COUNTY OF JAMES CITY
FINAL SITE PLAN

Plan No. SP - 101 - 00 Date/Time: 9/22/00 8:45AM
Project Name: JAMES CITY COUNTY SKATEBOARD PARK
Rough Location: ASHBURY ROAD ~~AT EASTERN STATE HOSPITAL~~ NEAR JCC REC CENTER.
ADC Map: Sheet 5 Grid: J - 4 ☐ First Review
Flood Map / Zone: 510201- 00 35B Zone: X ☐ ____ Review
Description: outside 500-YR FLOODPLAIN
Drainage Area: ☐ Onsite Only ☐ Offsite Only ☒ Combination of Both
Submitted:

RE: James City County Skatepark
JCC Case No. S-101-00
AES Project No. 8651-8

ENVIRONMENTAL DIVISION REVIEW COMMENTS
JAMES CITY COUNTY SKATE PARK
PLAN NO. SP - 101 - 00
December 12, 2000 MDW / SJT

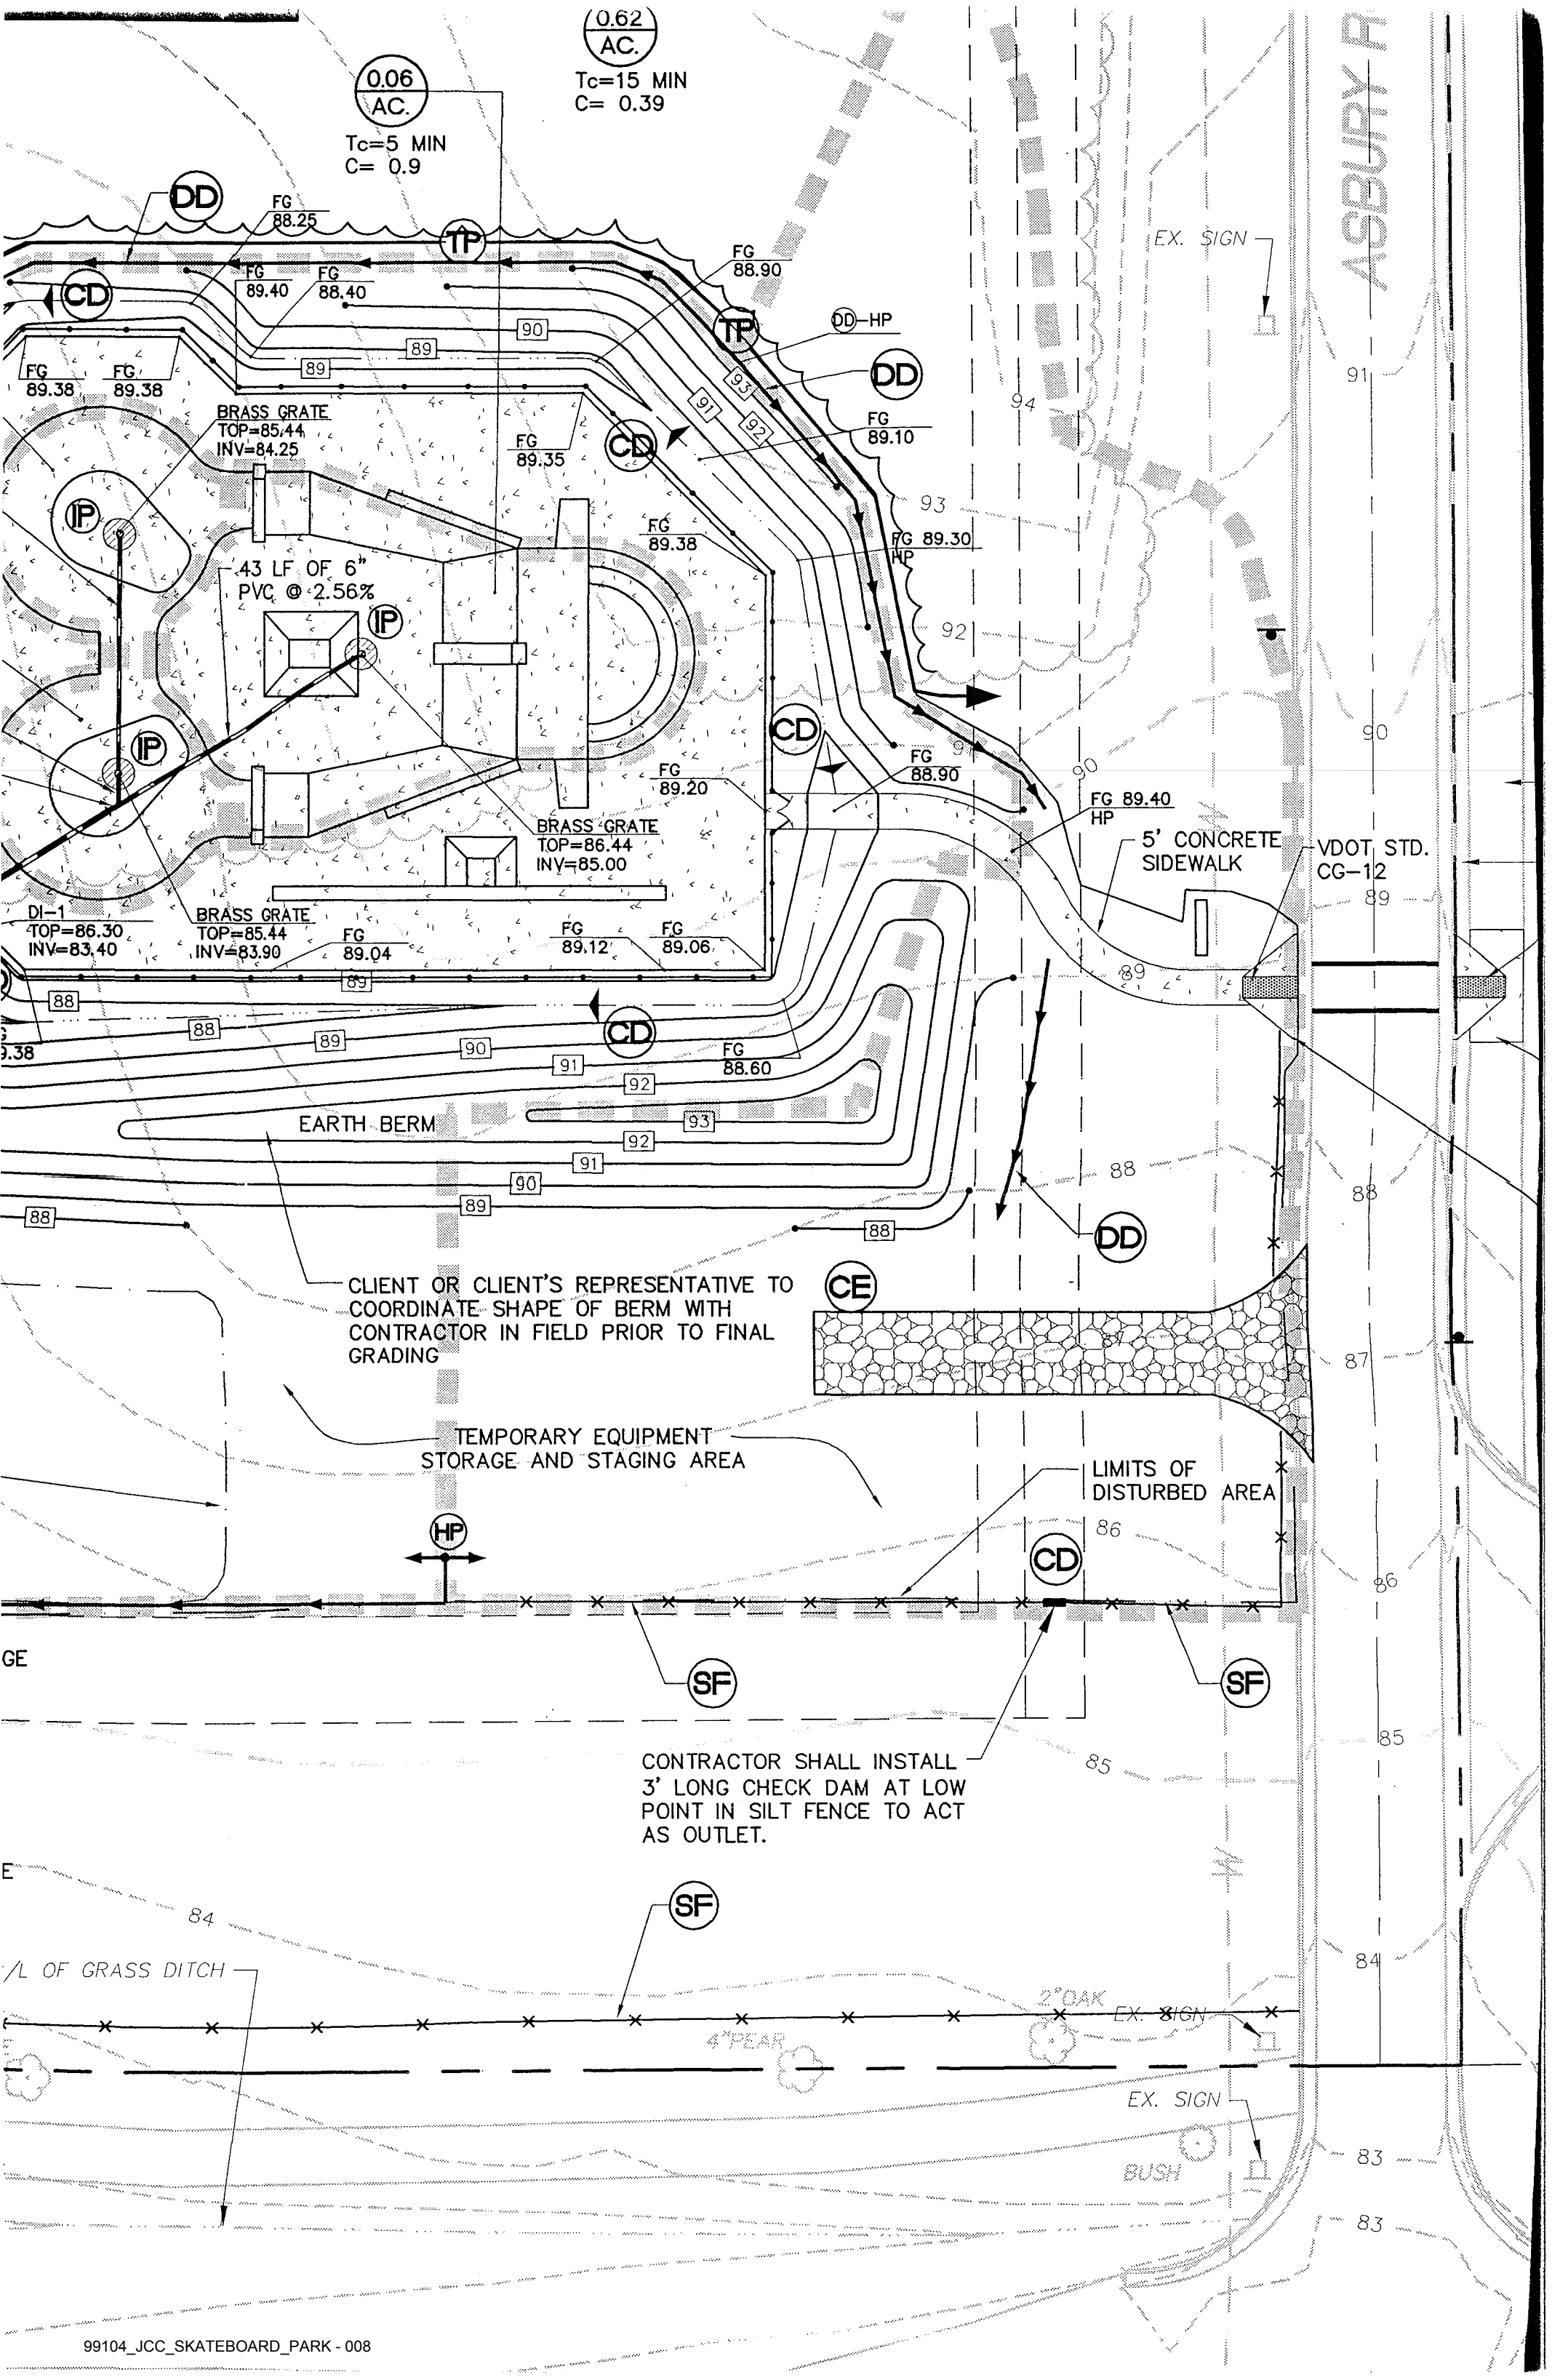
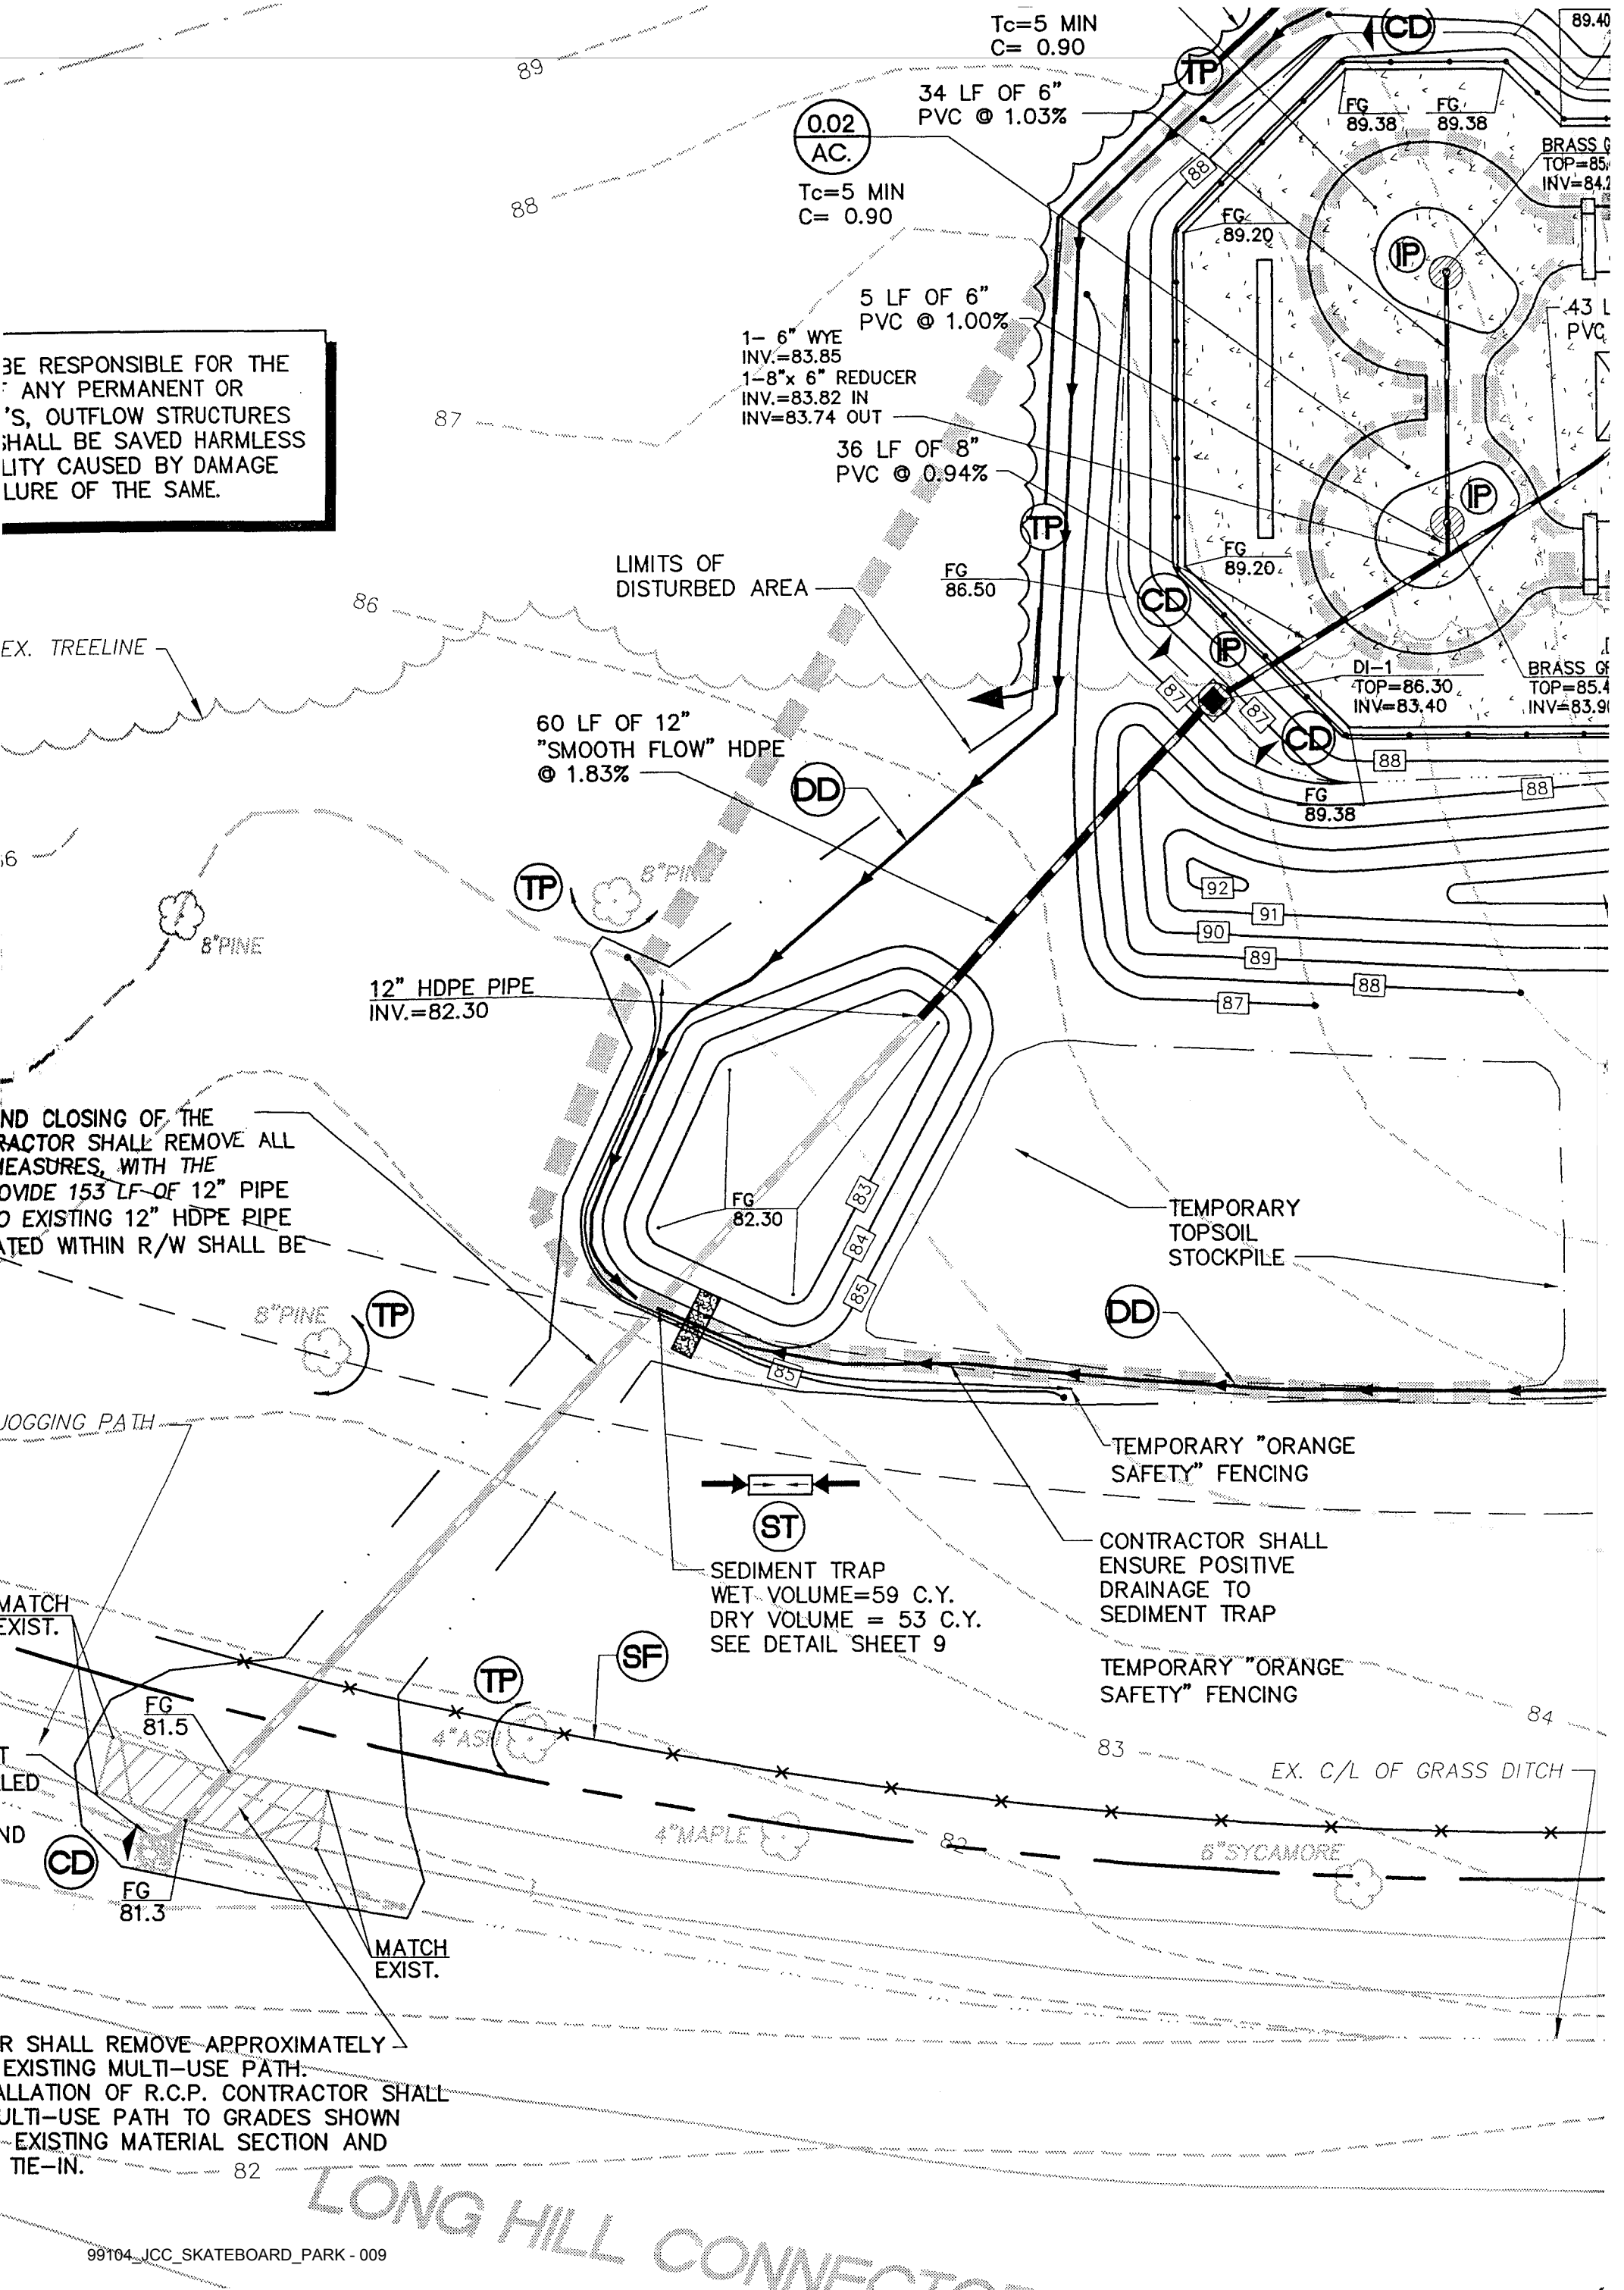
1. Temporary Sediment Trap. Use of temporary plastic safety fence was not implemented as recommended along the lower (southern) portion of the sediment trap. VESCH Minimum Standard and Specification 3.01 recommends that this practice is to be applied where control measures are considered unsafe by virtue of access by the public. Regardless of wet or dry volume depth, the sediment trap is in very close proximity to the sidewalk along Longhill Road Extension and the area between the sidewalk and the trap is in a relatively cleared state and the trap could be easily accessed.

2. Sidewalk Cross Culvert. In accordance with MS-19 of the Virginia Erosion and Sediment Control regulations, pipe improvements shall be designed so the 10-year storm is contained within the appurtenances and pipes and storm sewer systems shall be analyzed by the use of a 10-year storm to verify that stormwater will be contained within the pipe or system. Based on the 10-year design headwater computations as submitted for the 15 inch RCP culvert across the sidewalk, it appears the culvert is under inlet control and the headwater elevation on the upstream side of the culvert would overtop the sidewalk, thus creating an undesirable condition. Two alternatives exist to correct this situation. The preferred arrangement is to eliminate the 70 l.f. of stormwater conveyance channel and put the entire system into properly sized underground storm drain. This alternative would eliminate the open channel segment, which again is in close proximity to the sidewalk; however, it would require installation of storm drain manholes due to directional changes. The alignment could be slightly revised to eliminate the need for two additional manholes. The second option would consist of keeping the current open channel segment and up-sizing the cross-culvert to prevent headwater overtopping of the sidewalk for the design storm event. Provide revised storm drain or culvert headwater computations depending on the selected scenario.

3. Outlet Protection. In accordance with MS-19, for sites where runoff is discharged into a pipe, downstream stability analyses at the outfall of the pipe shall be performed. Address outlet protection or energy dissipation requirements at the outfall (south) end of the sidewalk culvert to prevent erosion. The velocity at the outfall end of the 15 inch pipe could as high as 7-8 fps for a 15 inch pipe, exceeding the permissible velocity of the grass channel at the outfall point.

2. ✓ Existing Channels. On Sheets 2 and 4, clearly designate the grassed and paved channel locations along the north side of Long Hill Connector. It is important to know the start location of the paved concrete channel relative to the onsite outfall.

3. ✓ Staging & Equipment Storage. Show any temporary staging and equipment storage areas (with required erosion and sediment controls) or indicate on the plans that none are anticipated for the project site. It would appear a staging area may be needed due to the amount of rebar/concrete work and potential equipment associated with this specialized site.

4. ✓ Topsoil Stockpile. Provide a temporary diversion dike. rather than silt fence, along the south (downslope) side of the temporary soil stockpile. Ensure the diversion dike properly intercepts runoff from the pile and conveys it to the sediment trap. Adjust sediment trap computations as required due to acceptance of additional drainage area.

5. ✓ Limits of Work. Modify the limits of disturbed area as shown on the plan to encompass the construction entrance and proposed sign area. Also, since installation of the sediment trap is proposed as one of the first steps of sitework, initially there may be the need for more direct access to the trap. Adjust the limit of disturbed area southward as necessary.

6. ✓ Upslope Diversion Dikes. The upslope temporary diversion dike need to be fully extended westward around the sediment trap. Also, the upslope diversion dike which extends from the diversion dike - high point in an east direction can be removed. There is no defined drainage feature to adequately outlet runoff from the diversion to other than curbside at Ashbury Road. Adjust sediment trap computations as required to compensate for the loss this eastern diversion dike.

7. ✓ Downslope Diversion Dike. Ensure the downslope temporary diversion dike which collects runoff from disturbed portions of the site is properly located to adequately drain into the sediment trapat the northeast corner.

11. Tree Protection. Provide tree protection around the existing pines and ash trees near the stormwater outfall work vicinity. These trees are highly visible and should be preserved to the greatest extent possible.

12. Silt Fence. Add silt fence south (downslope) of the east portion of the CG-12 and 5 ft. sidewalk walkway area or alternatively wrap the temporary diversion dike eastward to cover this disturbed area. Otherwise, disturbance from this area would be uncontrolled toward Ashbury Road.

1. Please see sheet 4 for the location of the temporary safety fencing for the sediment trap.
2. See sheet 4 for the revised storm drainage system layout. The supporting calculations have also been revised and are included.
3. As discussed with Mr. Scott Thomas of the JCC Environmental Division and Mr. P.K. Das of the Virginia Department of Transportation, Pyramat turf reinforcement matting has been added to the plans in lieu of standard outlet protection stone. It has been agreed that this form of outlet protection will help to benefit the proposed outfall from both an aesthetic and maintenance standpoint.
4. The proposed pipe system has excess capacity for the minimal amount of future development that could potentially take place south of the skatepark. Additionally, upon reaching a site impervious cover of 10%, overall site water quality will need to be provided.

2. See sheet 2 and 4 for the location and the type of the existing channels.
3. See sheet 4 for the location of the temporary staging and equipment storage areas.

4. The diversion dike has been added to sheet 4 and the sediment trap calculations have been revised. See the attached calculations.
5. See sheet 4 for the limits of the proposed disturbed area.

6. The diversion dike has been extended all the way around the sediment trap. The diversion dike at the northeast portion of the site has not been removed because the flow will be contained within grassed area adjacent to the existing roadway and it will outlet through the check dam to be installed at the low point of the silt fence located in the southeastern portion of the site.

7. The configuration of the diversion dike has been revised. A stretch of silt fence with a check dam outlet has been located in the southeastern portion of the site.

10. See sheet 8 and 9 for the detail for the silt fence inlet protection insert for the proposed grates within the skatepark area.
11. See sheet 4 for the location of the tree protection as requested.

15. ✓ A cross culvert has been added to the construction plans to convey stormwater under the existing multi-use asphalt path and discharge it into an adequate channel.
